From: Jonothon Butters [REDACTED]
Sent: 19 August 2026 15:12
To: Planning <Planning@arun.gov.uk>
Subject: Comments on Planning Application WA/68/26/PL — Land North of The Green Way, West Walberton Lane, Walberton (comment deadline 4 September 2026)

Re: WA/68/26/PL — Land North of The Green Way, West Walberton Lane, Walberton, BN18 0QS

SITE TITLE PLAN
DEVELOPMENT AT:
DEVELOPMENT AT LAND SOUTH OF
ARUNDEL ROAD, FONTWELL
FOR
ELIVIA HOMES SOUTHERN LIMITED

Scale : 1:750 @ A3 Date : March 2022
Drawing No : 54_17_150_B

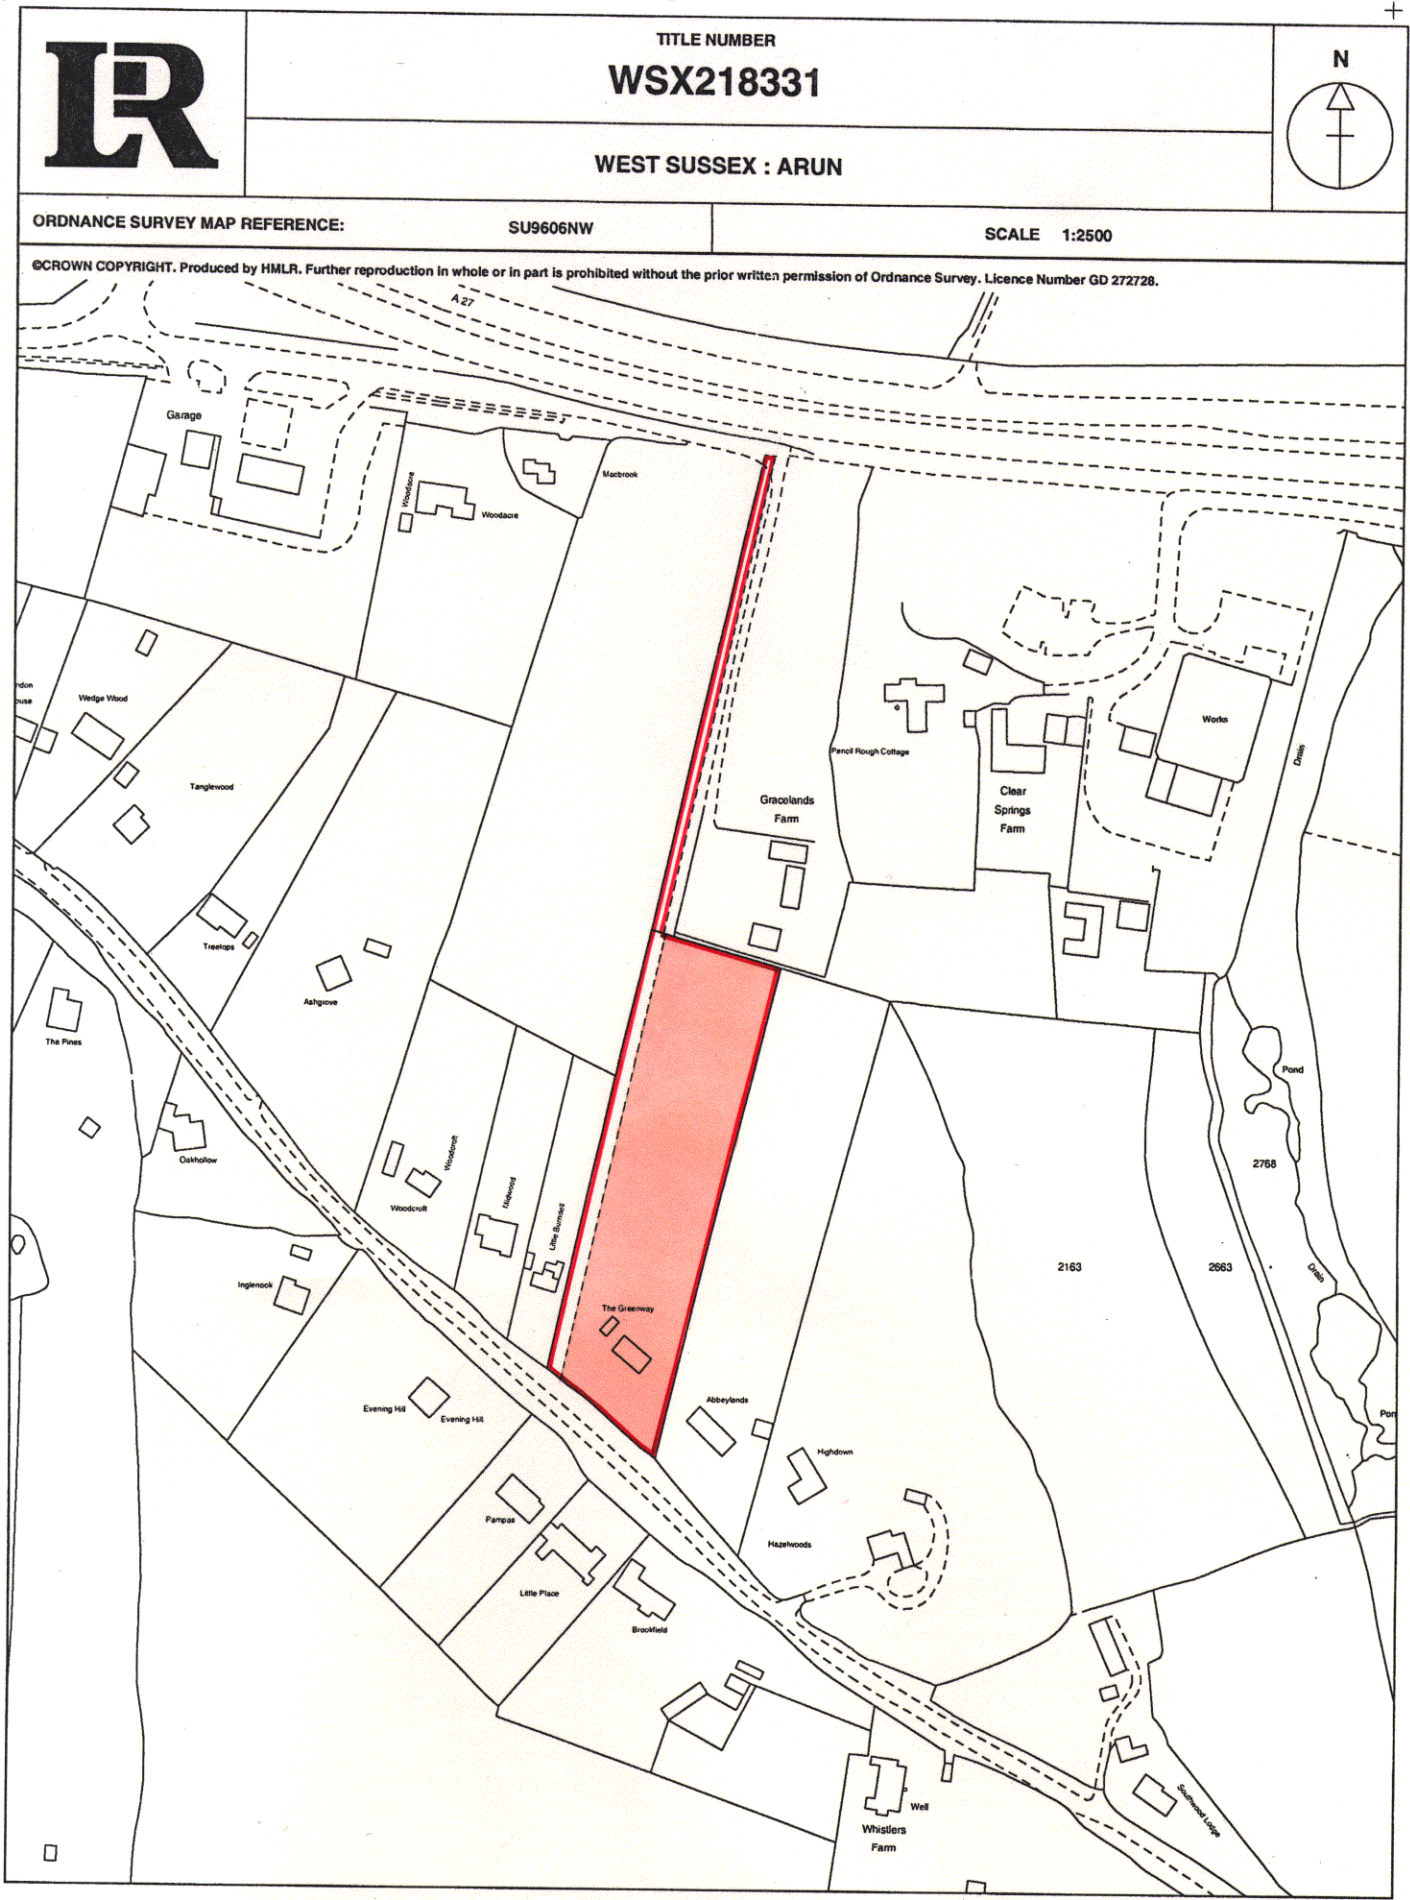
I have compared these drawings against Elivia Homes Southern's own Site Title Plan for the Daffodil Gardens estate (Drawing No. 54_17_150_B, "Plan 2", dated March 2022, revised 3 May 2024 — **copy attached**, as I understand this may not otherwise be readily available to you). On that plan, the same corridor is shown as two distinct strips — an area marked "Estate landscaped areas subject to right of way," and, immediately alongside it, a separate "300mm Wide Ransom Strip" — both narrowing noticeably as they approach the Arundel Road frontage. The application's own drawings, by contrast, show this corridor at a materially wider, constant width throughout, including at the road junction.

I have also reviewed the HM Land Registry title register and title plan for The Green Way, Title No. WSX218331 (**copy attached** — publicly obtainable from HM Land Registry). This shows the property was first registered on 22 December 1997 with a larger original extent, and that on 29 June 2000 "a new filed plan... showing an amended extent" was registered — reducing the title to its current, smaller footprint. The land removed at that point appears to correspond to the same corridor now shown as "subject to right of way" on Elivia's site plan.

- What is the documented legal basis and width of the vehicular right of way the applicant is relying on for access?
- Does that right extend to the fuller width shown in the application drawings, or is it limited to the narrower corridor shown on the estate's own title plan?
- Has the applicant provided evidence of legal entitlement to use the access at the width shown — including in respect of the separate 300mm ransom strip, which by its nature is designed to require the owner's consent?
